CITY of NOVI CITY COUNCIL

Agenda Item 1
April 1, 2019

SUBJECT: Approval of the request of Applicant Erhard Motor Sales, Inc., and Developer Winfried Dahm, JSP 17-65 for a Preliminary Site Plan with a Special Development Option (SDO), Wetland Permit, Woodland Permit, and Stormwater Management Plan in the GE, Gateway East District. The subject property is 9.48 acres of land located at the southwest corner of Grand River Avenue and Meadowbrook Road, in Section 23. The applicant is proposing a 58,663 square foot car sales facility for Jaguar Land Rover.

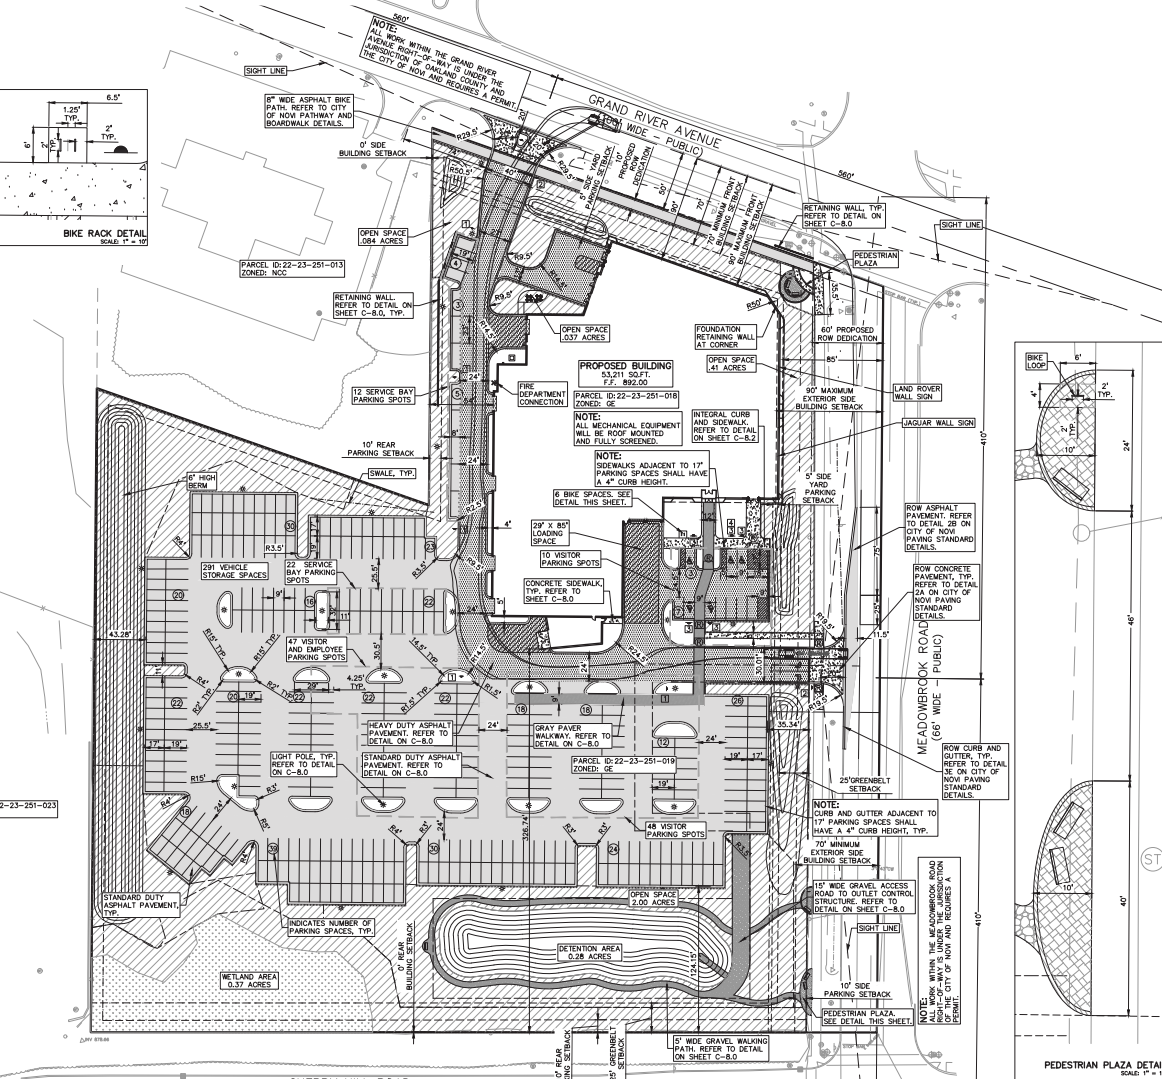
- i. **It should also be noted that the note on sheet C-3.0 indicates four inch curbs while the detail on sheet C-8.0 indicates 6” curbs.**
 - ii. **The applicant should indicate that 6” curbs are required at the parking end islands.**

- f. The applicant is required to provide two (2) bicycle parking spaces for the service center section of the development and six (6) have been provided. A bicycle parking layout is shown on sheet C-3.0 but a **dimension for the width of the sidewalk should also be included.**

- i. **The detail shown is for four (4) bicycle parking spaces and not the six (6) that the data table on sheet C3.0 states are provided.**
 - ii. The bike loop detail on sheet C-8.0 is in compliance with City standards.

- i. It should also be noted that the note on sheet C-3.0 indicates four-inch curbs while the detail on sheet C-8.0 indicates 6" curbs.

- f. The applicant is required to provide two (2) bicycle parking spaces for the service center section of the development and six (6) have been provided. A bicycle parking layout is shown on sheet C-3.0 but a dimension for the width of the sidewalk should also be included.

- i. The detail shown is for four (4) bicycle parking spaces and not the six (6) that the data table on sheet C3.0 states are provided.

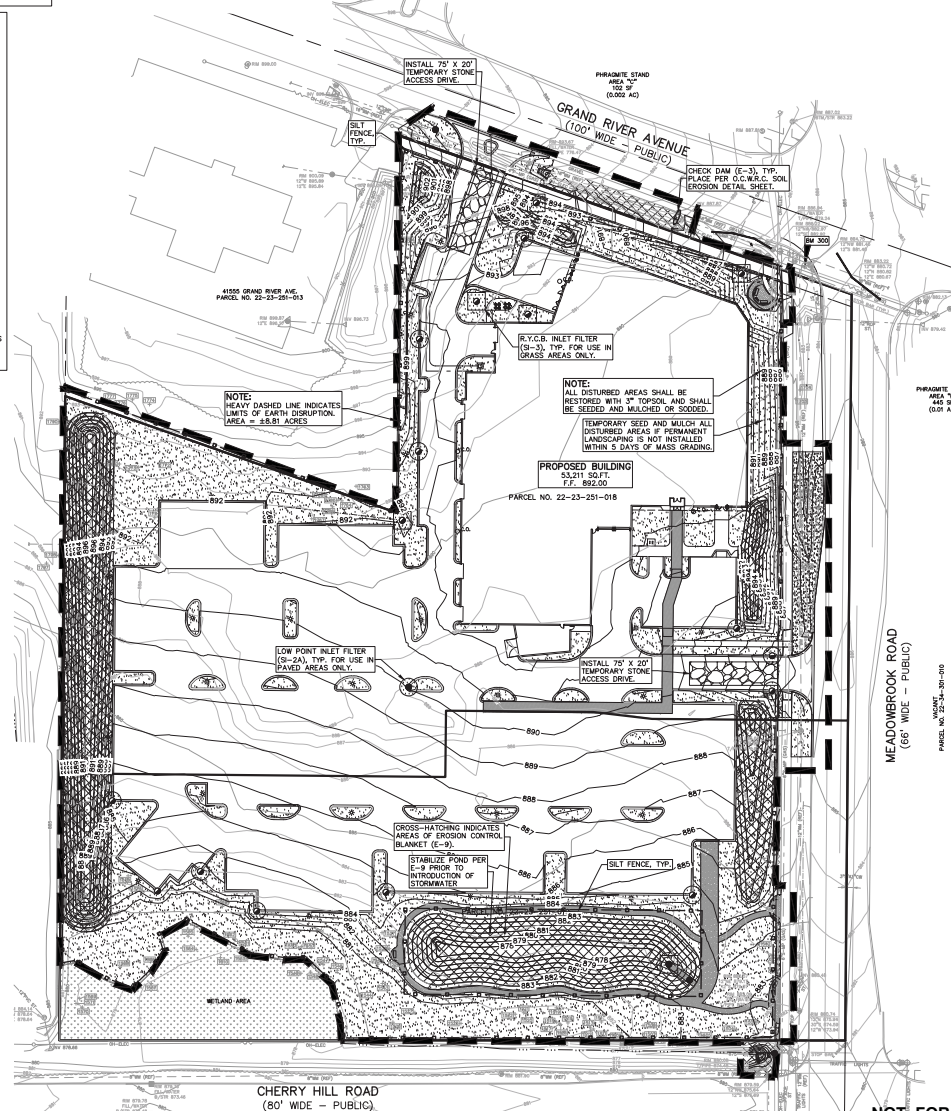
The *SESC Plan* (Sheet C-5.0) appears to indicate that the majority, if not all, of the existing 25-foot natural features setback will receive temporary seed and mulch. The *Grading Plan* (Sheet C-4.0) does not appear to indicate grading within the 25-foot setback, except for within the area of the stormwater detention basin outfall pipe. The applicant shall clarify the intent of the temporary seed and mulch that is proposed within the 25-foot setback. Twenty-five-foot buffers are intended to contain native plant types, and sod or common grass seed is not desirable in these areas. Please clarify the intent and type of the proposed seed mix and mulch within this area.

The SESC Plan (Sheet C-5.0) appears to indicate that the majority, if not all, of the existing 25-foot natural features setback will receive temporary seed and mulch. The Grading Plan (Sheet C-4.0) does not appear to indicate grading within the 25-foot setback, except for within the area of the stormwater detention basin outfall pipe. The applicant shall clarify the intent of the temporary seed and mulch that is proposed within the 25-foot setback. Twenty-five-foot buffers are intended to contain native plant types, and sod or common grass seed is not desirable in these areas. Please clarify the intent and type of the proposed seed mix and mulch within this area.

ORIGINAL ISSUE DATE: FEBRUARY 11, 2019
PEA JOB NO. 2017-176
SCALE: 1" = 50'
DRAWING NUMBER: L-1.0

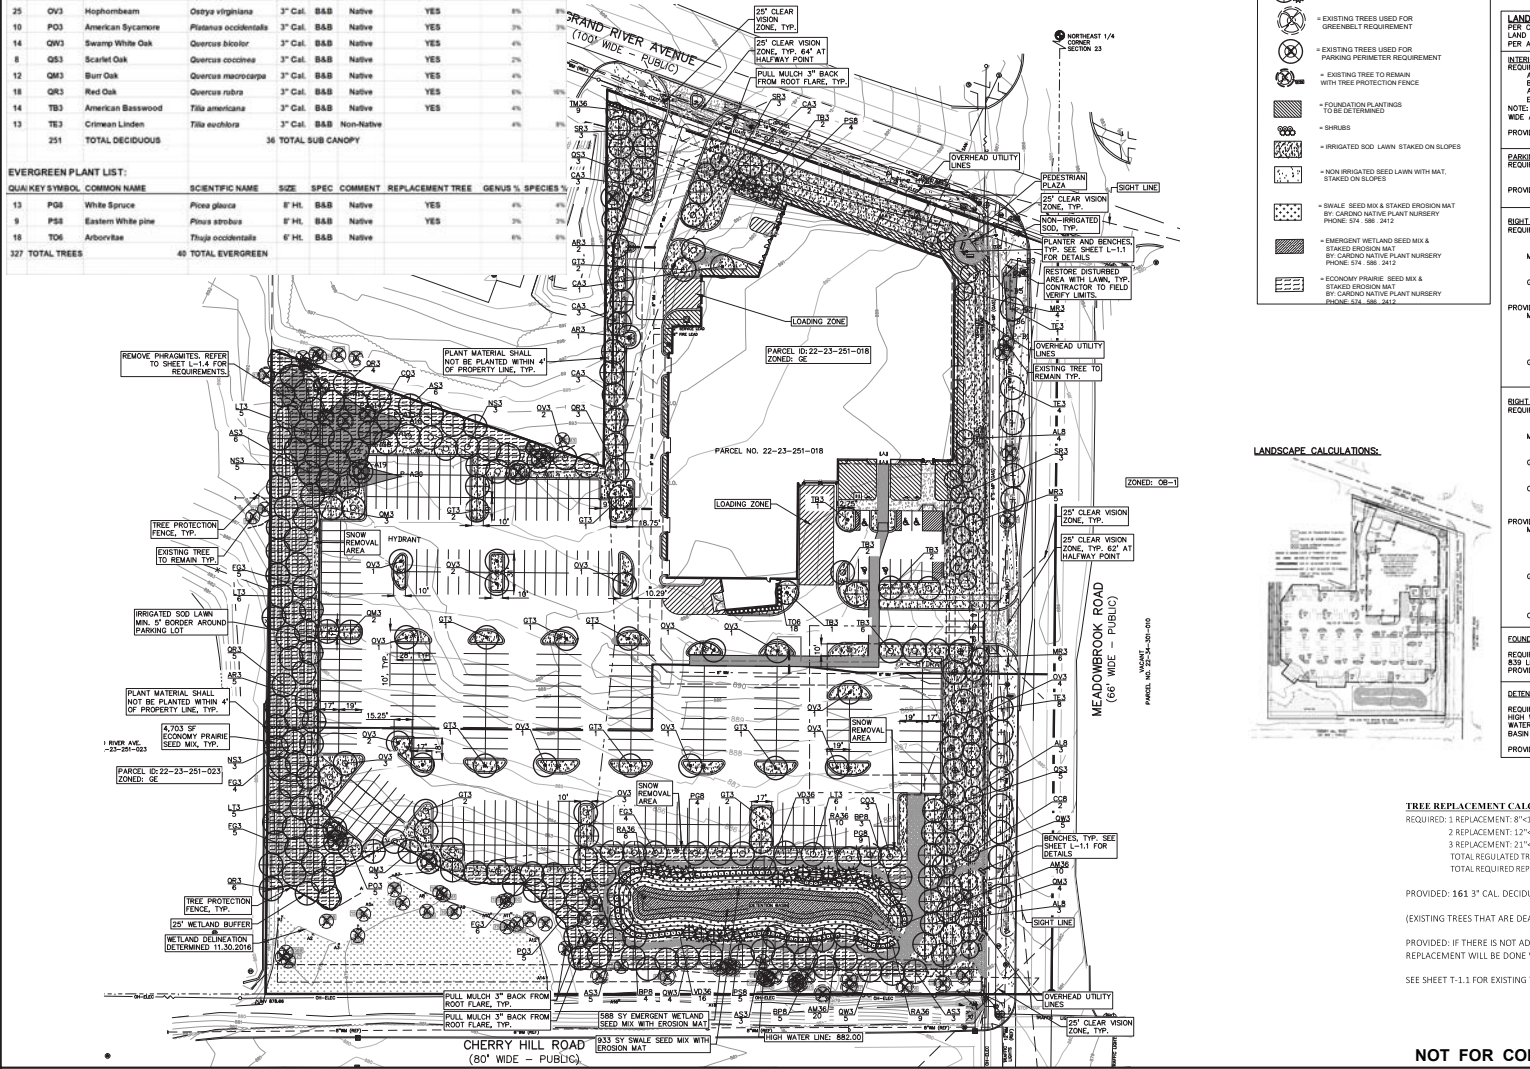
Please copy the above deviations, including the meeting date, to Sheet L-1.0 of the Landscape Plans.

The Plan includes a *Tree Plant List* on the *Landscape Plan* (Sheet L-1.0), that lists the species of the proposed Woodland Replacement Trees; however it does not currently appear to specify the quantity of each species that will be used as Woodland Replacement tree credits in the table. The applicant should, for example, specify how many of the 25 hophornbeam listed in the list are Woodland Replacement Trees as opposed to Perimeter Parking Lot or Landscape trees, etc. ECT requests that the applicant provide the quantity of each species of tree being used as Woodland Replacement Credit in the 'Replacement Tree' column of the table.

This comment still applies. The Tree List is included on Sheet L-1.0 (Landscape Plan). The applicant should, for example, specify how many of the 25 hophornbeam listed in the list are Woodland Replacement Trees as opposed to Perimeter Parking Lot or Landscape trees, etc. ECT requests that the applicant provide the quantity of each species of tree being used as Woodland Replacement Credit in the 'Replacement Tree' column of the table.

Please copy the above deviations, including the meeting date, to Sheet L-1.0 of the Landscape Plans.

This comment still applies. The Tree List is included on Sheet L-1.0 (Landscape Plan). The applicant should, for example, specify how many of the 25 hophornbeam listed in the list are Woodland Replacement Trees as opposed to Perimeter Parking Lot or Landscape trees, etc. ECT requests that the applicant provide the quantity of each species of tree being used as Woodland Replacement Credit in the 'Replacement Tree' column of the table.

Response: Noted. Deviations will be added to sheet L-1.0.

DRAWING NUMBER:
T-1.0

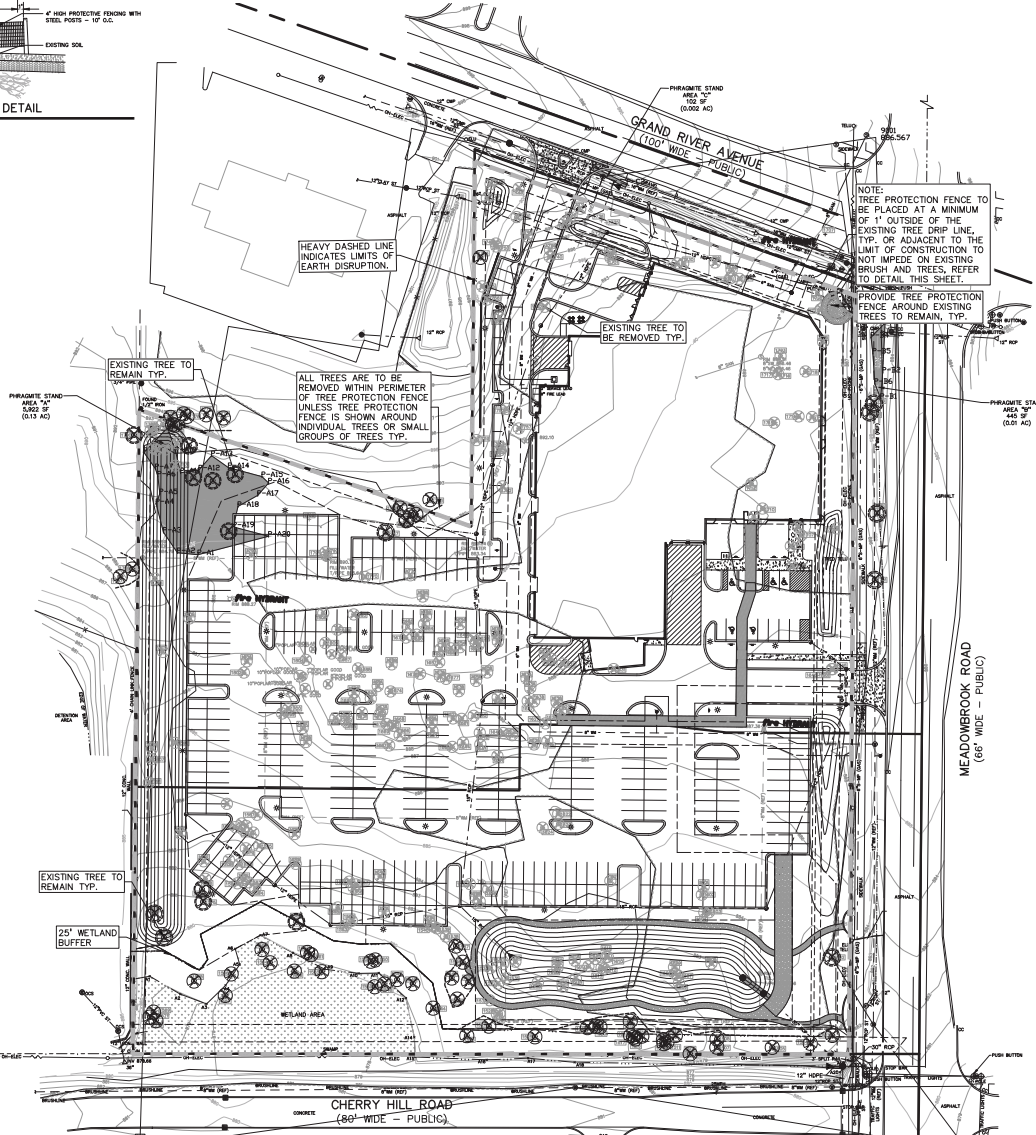
The *Tree Preservation Plan* (Sheet T-1.0) notes that **173** Woodland Replacement Tree credits are required and that a total of **173** on-site Woodland Replacement Tree credits are proposed with a mix of canopy (deciduous) trees and evergreen trees.

2. The Plan includes a *Tree Plant List* on Sheet T-1.0, that lists the species of the proposed Woodland Replacement Trees; however it does not currently appear to specify the quantity of each species that will be used as Woodland Replacement tree credits. The applicant should, for example, specify how many of the 28 hophornbeam listed in the list are Woodland Replacement Trees as opposed to Perimeter Parking Lot or Landscape trees, etc.

2. The Plan includes a Tree Plant List on Sheet T-1.0, that lists the species of the proposed Woodland Replacement Trees; however, it does not currently appear to specify the quantity of each species that will be used as Woodland Replacement tree credits. The applicant should, for example, specify how many of the 28 hophornbeam listed in the list are Woodland Replacement Trees as opposed to Perimeter Parking Lot or Landscape trees, etc.

Figure 1. City of Novi Regulated Wetland & Woodland Map (approximate project boundary shown in red). Regulated Woodland areas are shown in green and Regulated Wetland areas are shown in blue.

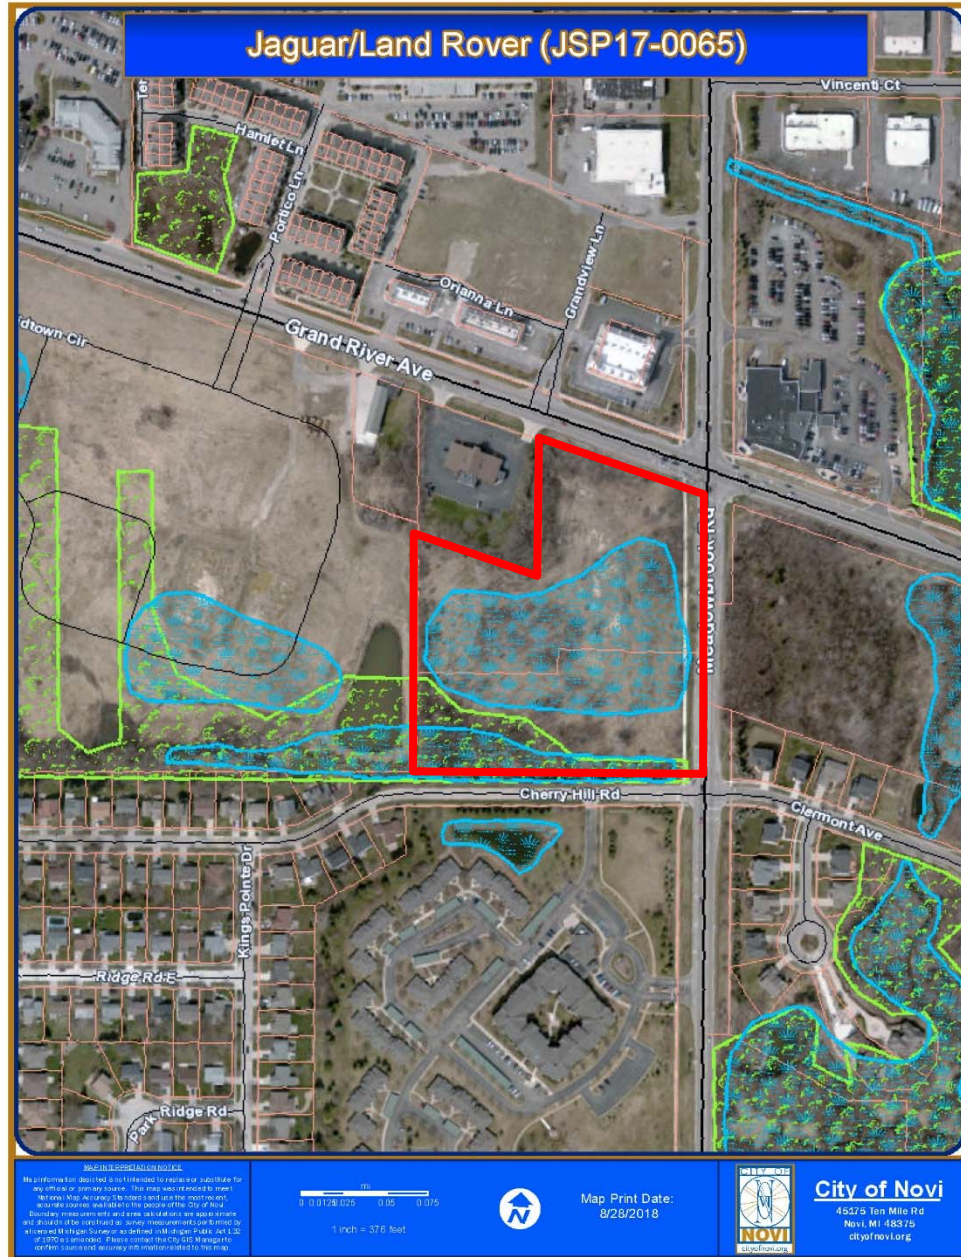
ECT previously verified that the Wetland A boundaries appeared to be accurately flagged in the field and depicted on the Wetland Location Map. It can be noted that the City of Novi's Regulated Wetland Map (Figure 1) is not accurate in indicating the location of wetland on the subject property. The Wetland Location Map provided by Niswander Environmental (Figure 2) does appear to accurately portray the existing wetland location and this appears to be accurately portrayed on the Plan.

As noted above, the Plan indicates one (1) area of wetland on this site located along the southern boundary. Portions of this wetland area appear to be included on the City of Novi *Regulated Wetlands and Watercourse Map* (see Figure 1, attached). The Plan appears to propose one (1) area of wetland/watercourse impact for the removal of existing culvert end sections, the installation of a storm water outlet pipe from the proposed detention basin to the drain, and associated grading. **The current Plan does not appear to label or**

1. As noted above, the Plan indicates one (1) area of wetland on this site located along the southern boundary. Portions of this wetland area appear to be included on the City of Novi Regulated Wetlands and Watercourse Map (see Figure 1, attached). The Plan appears to propose one (1) area of wetland/watercourse impact for the removal of existing culvert end sections, the installation of a storm water outlet pipe from the proposed detention basin to the drain, and associated grading.
